GENERAL APPLICATION

Location Address: 1604 Cleveland St. Hollywood, FL 33020

The following are the responses to your plans review comments of the above mentioned project:

NEW TOWNHOUSE FOR:
CLEVELAND HOMES LLC.
1604-1606 CLEVELAND ST.
HOLLYWOOD, FL 33020

2 TYPICAL UNIT A SECOND FLOOR PLAN
1/4" = 1'-0"

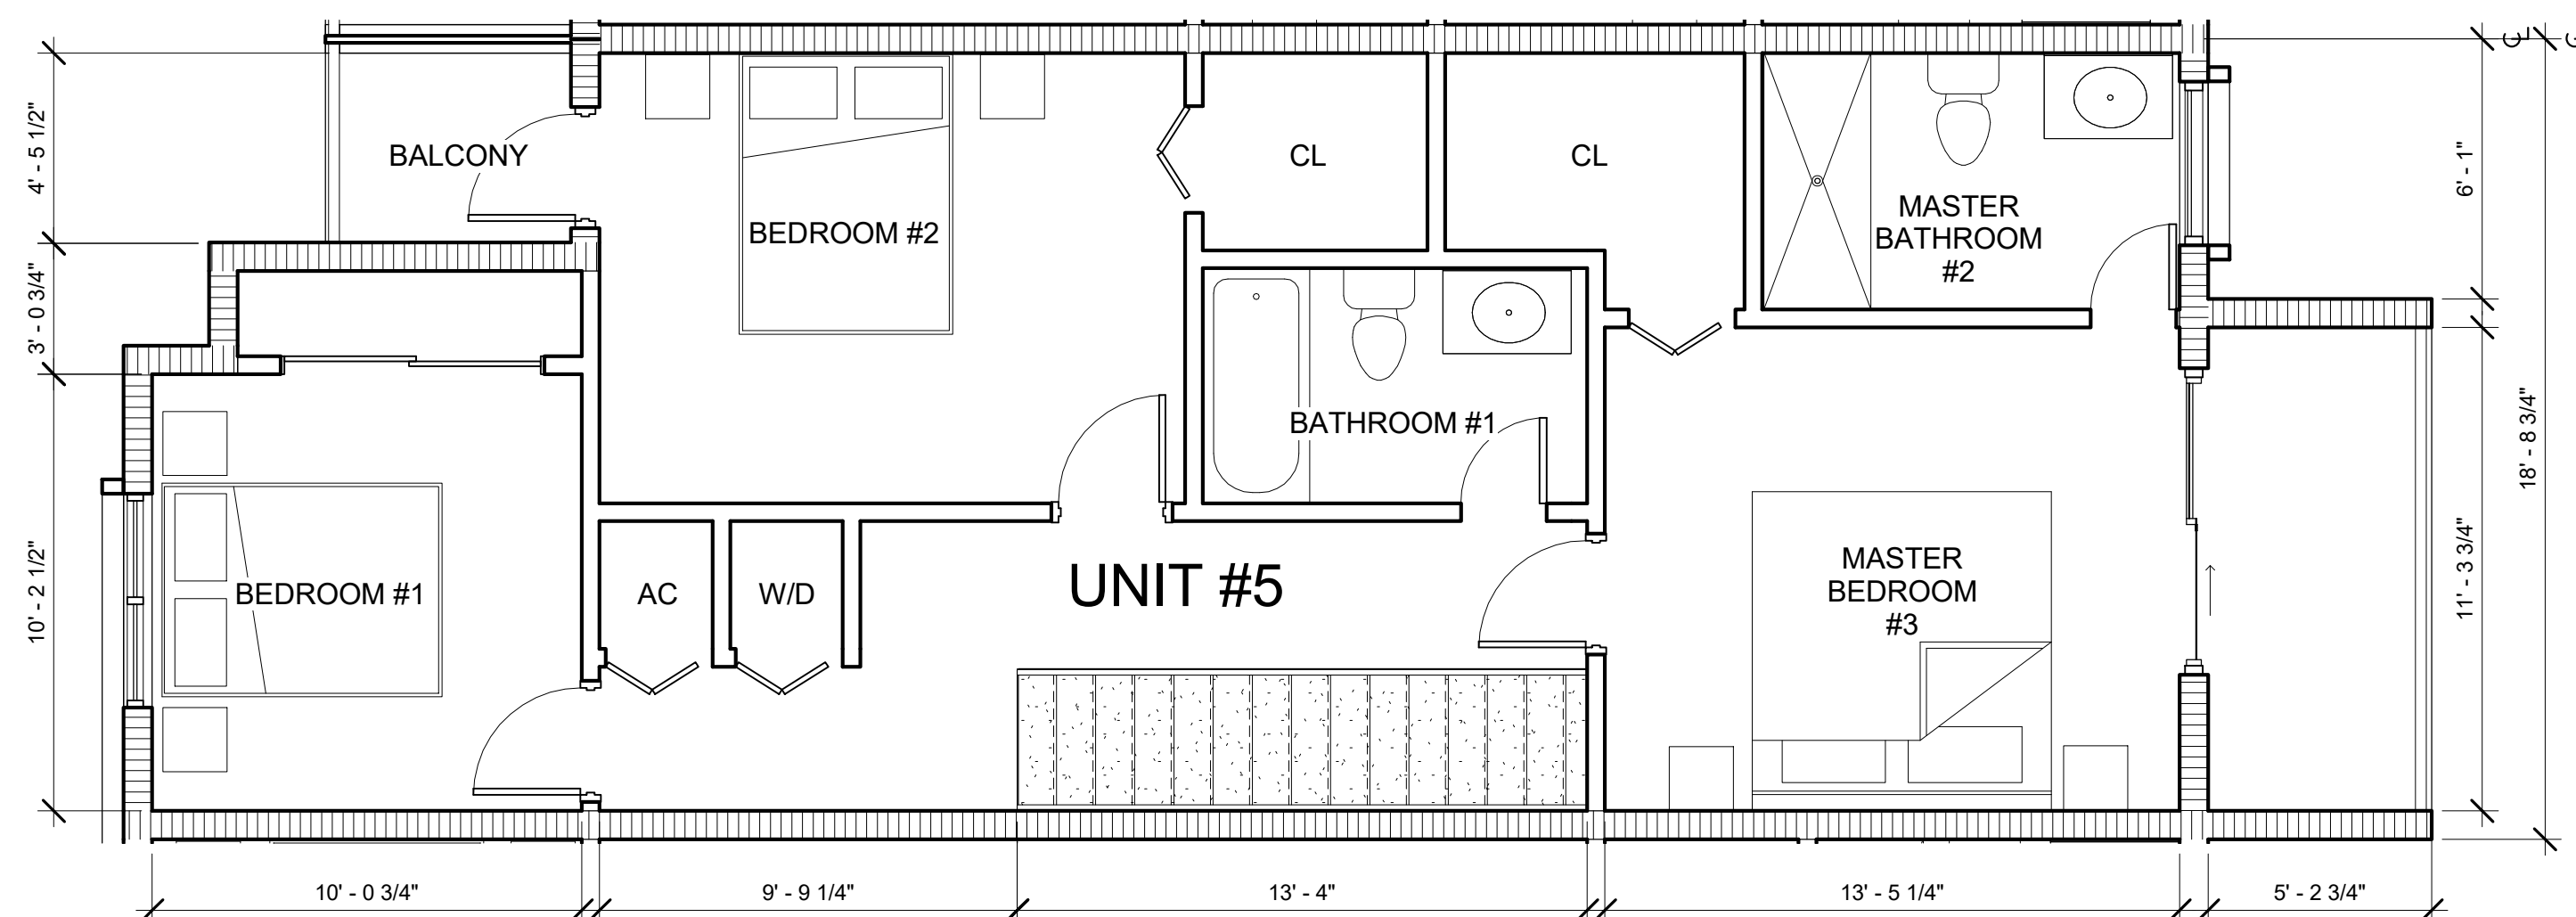
5. Sheet A6.0:

- a. Dishwashers appear to be located in the kitchen island. Consider relocating d/w adjacent to sink
- b. Master bedroom and master bathroom labels are reversed in Unit #1.
- c. Show details of master bathroom in Unit #5.

R: See revised floor plans. (REMIND MIGUEL)

1 CONCEPTUAL PAVING, GRADING AND DRAINAGE PLAN
1/8" = 1'-0"

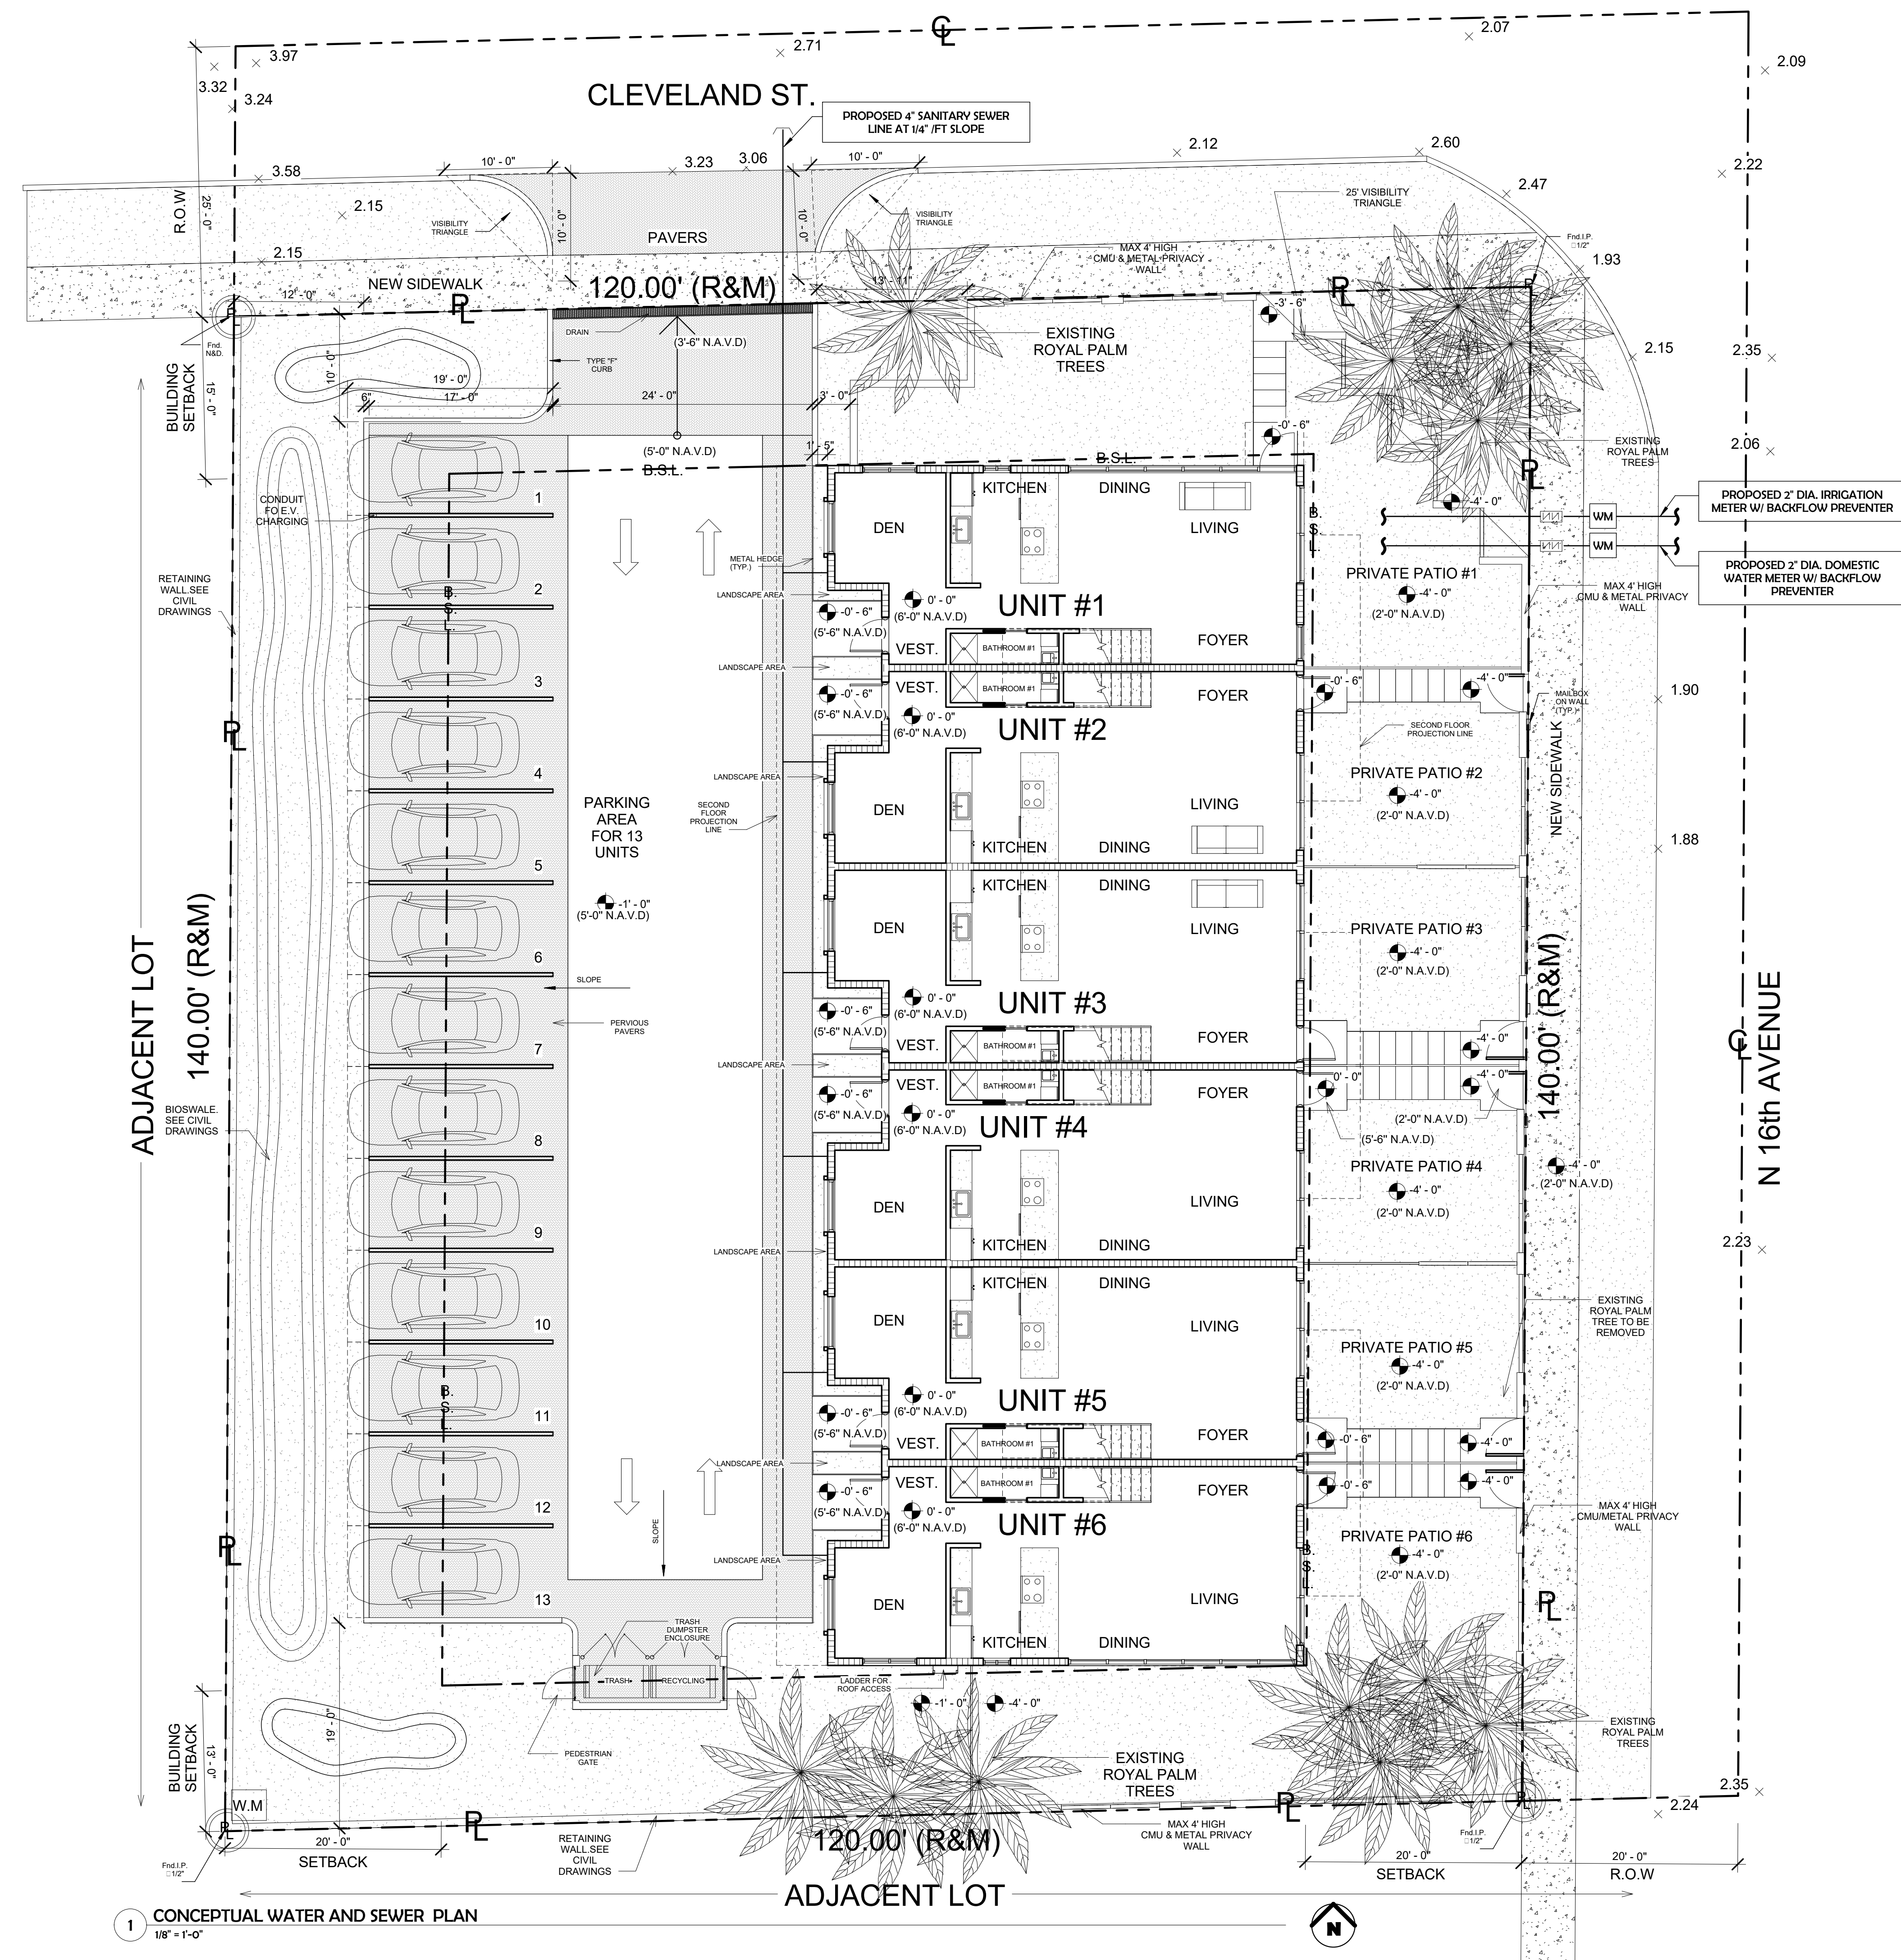
3. Provide site grading and drainage plan to show how you propose to collect and retain stormwater drainage on your own property and to show that site grades will not be raised. Suggestion to maintain site grades you should consider using stem wall footer

4. Show how roof drainage will be tied into your drainage system.

R: See conceptual civil plan.

R: See conceptual civil plan.
